# MIAMI BEACH

Staff Report & Recommendation

Historic Preservation Board

SUBJECT: File No. 7594, **1029-1031 Lincoln Road – Capital One.**

City of Miami Beach Microfilm Plans #15919  
1941- Façade Detail

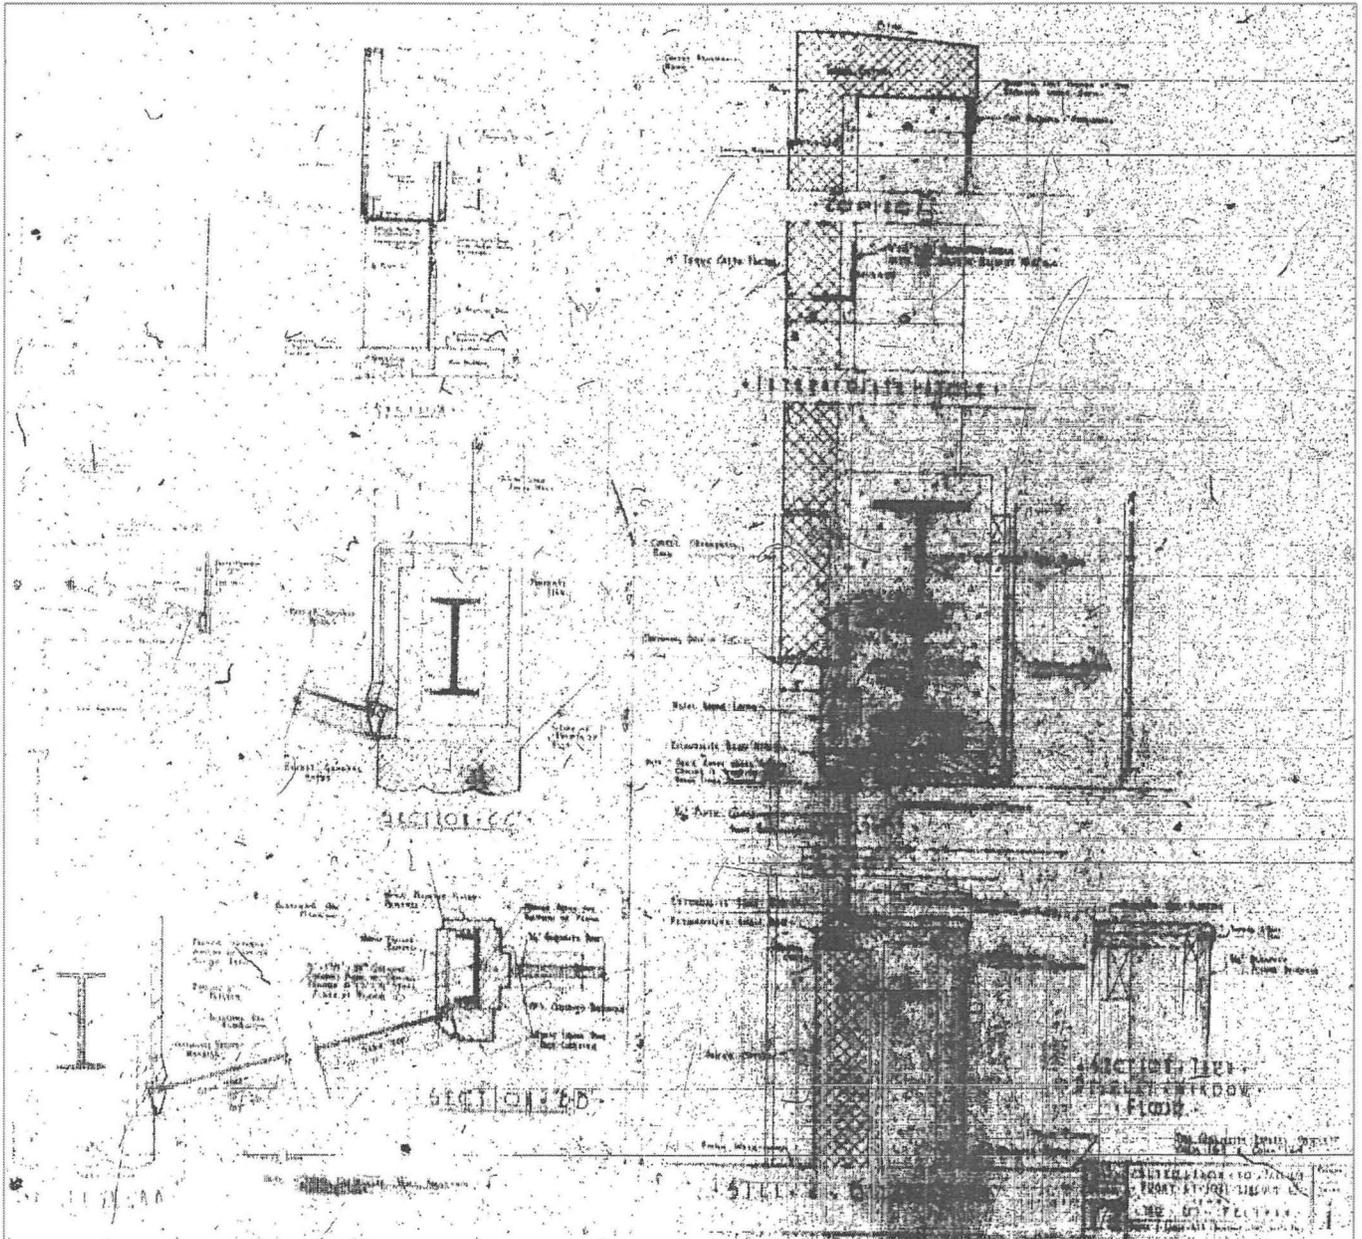
The most substantial alterations appear to have occurred in 1941 when the Lincoln Road façade was remodeled. A detail of the 1941 design, located on Microfilm #15919 (attached), shows a terracotta tile upper façade with fluted horizontal banding and fluted pilasters. At some point between 1942 and 1960, the eastern portion of the façade was substantially altered; arched openings, curved parapet and a small projecting balcony feature were introduced in what

The applicant is proposing a new façade design characterized by 14'-0" tall storefronts at the ground level and an angled projecting frame surrounding the upper façade. The upper façade is proposed to be clad with rectangular ceramic tiles set horizontally. The construction of this new façade will require the demolition of the ground floor angled storefronts, fluted horizontal banding, an approximately 4'-0" section of the upper façade directly above the storefronts, and the square terracotta tiles located on the upper façade.

Staff cannot support the demolition of the fluted horizontal banding features or the removal of the terracotta tiles, as both of these elements are historically and architecturally significant to the 1941 design. Additionally, staff would note that the approximately 4'-0" wall section located above the storefronts likely contains the structural tie beam supporting the upper portion of the building. It is not yet clear whether the removal of this section of wall will adversely impact the structural integrity of the building. Consequently, staff would recommend that the entire upper façade portion be retained and restored.

- a. The entire upper façade portion fronting on Lincoln Road shall be retained and restored, inclusive of the fluted banding and terracotta tiles, in a manner to be reviewed and approved by staff consistent with the Certificate of Appropriateness Criteria and/or the directions from the Board.
